Docket Number:	14-AAER-02
Project Title:	Computer, Computer Monitors, and Electronic Displays
TN #:	205767
Document Title:	ITI and Technet Comments: On April 15th Aggios Workshop Demo
Description:	N/A
Filer:	System
Organization:	Information Technology Industry Council/Chris Hankin
Submitter Role:	Public
Submission Date:	8/18/2015 8:37:03 AM
Docketed Date:	8/18/2015

ITI Technet Comments April 15th Aggios Workshop Demo

April 15th Aggios Workshop Demo.

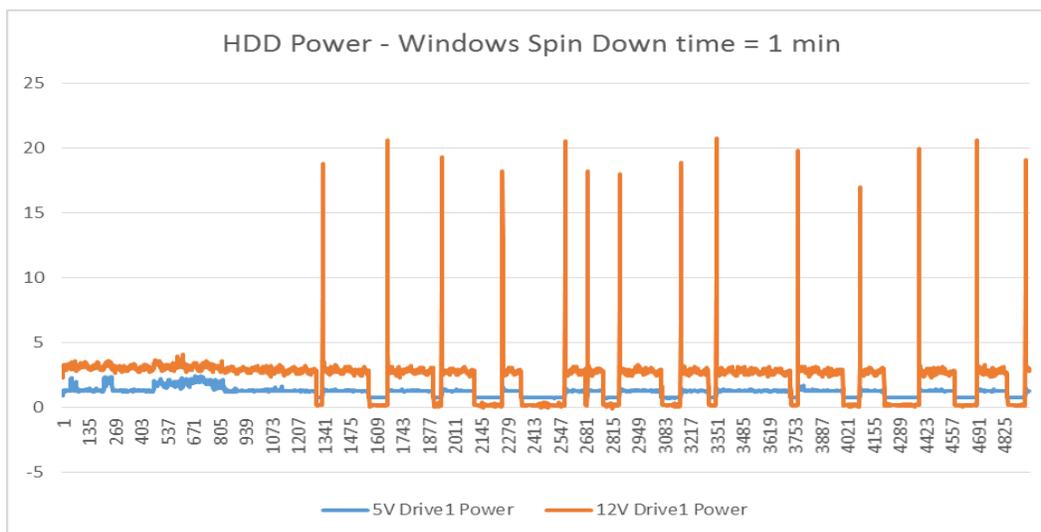
Industry's follow-up evaluation of the Aggios report is finding that some power issues were not identified. For example, power spikes are seen when HDDs are spun up (below). The power spikes during spin up can be more than the average HDD power, so that over 5 minutes, the energy consumed during spin-up is about the same as leaving the HDD in normal operational mode. This finding is missed in a discussion of power savings while spinning down HDDs.

The test results provided in the figure above were collected on a Western Digital Blue 1TB hard drive with the hard drive spin down time set to one minute in Windows.

Cost of changing to 2.5in HDD in desk top systems

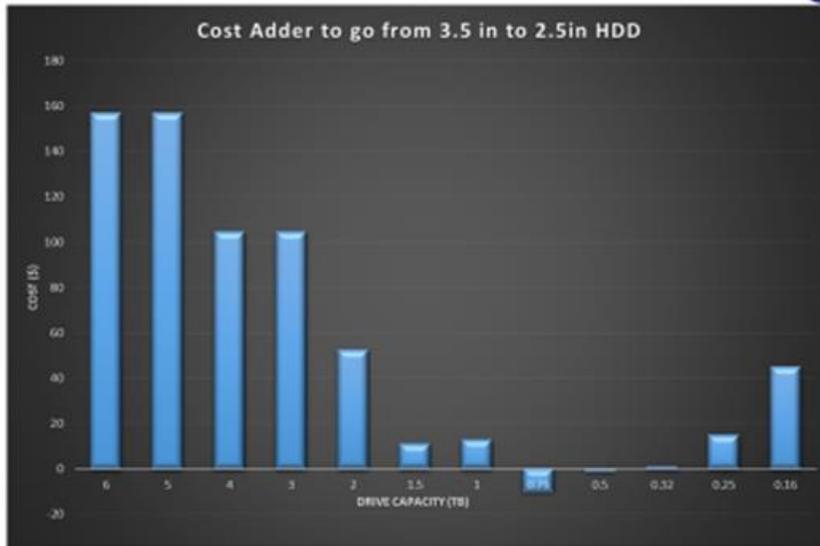
Cost impacts associated with changing PC system components are addressed in ITI TechNet collateral that's already been docketed. An example of one potential cost impact that is associated with making changes to HDDs is provided below.

- Uses lowest cost advertised on Amazon.com for available HDD's
- Western Digital and Seagate current production drives considered
- Customers needing large Capacity will experience between 50 and 150.00 per unit cost increase
